RE: Fawn Creek Subdivision (previously Leo's Place and Ashley Place II)

RE: LEO'S PLACE DRAINAGE PLAN

RE: LEO'S PLACE SUB. FINAL DRAINAGE PLAN

FINAL DRAINAGE PLAN REQUIREMENTS FOR LEO'S SUB:

5HT 2 of 2

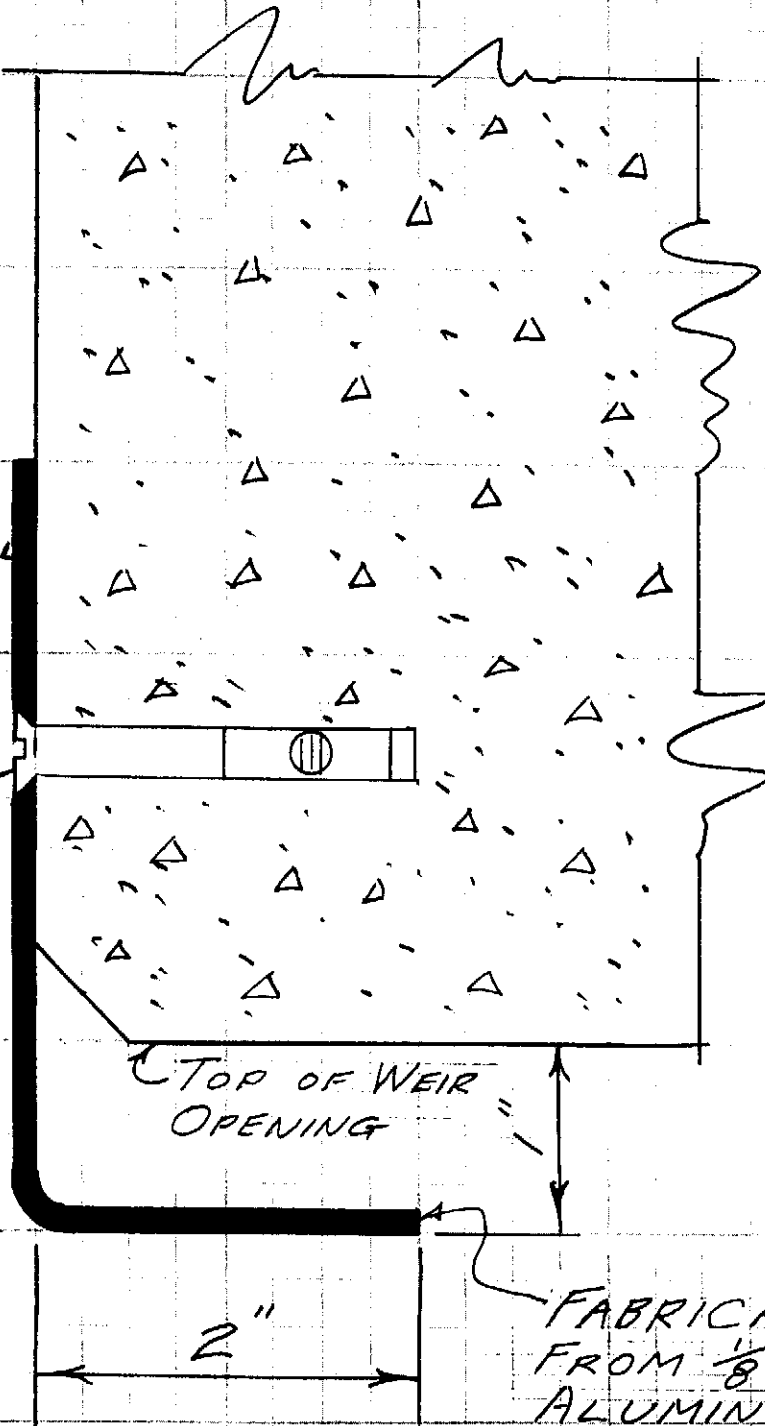
THE $H = 1.124'$ IS A 0.08' OR 1.0" REDUCTION IN THE HEIGHT OF THE WEIR. IF THE RELEASE STRUCTURE HAS BEEN CONSTRUCTED IT CAN MODIFIED BY INSTALLING AN ALUMINUM ANGLE PIECE AS SHOWN ON SHEET 2
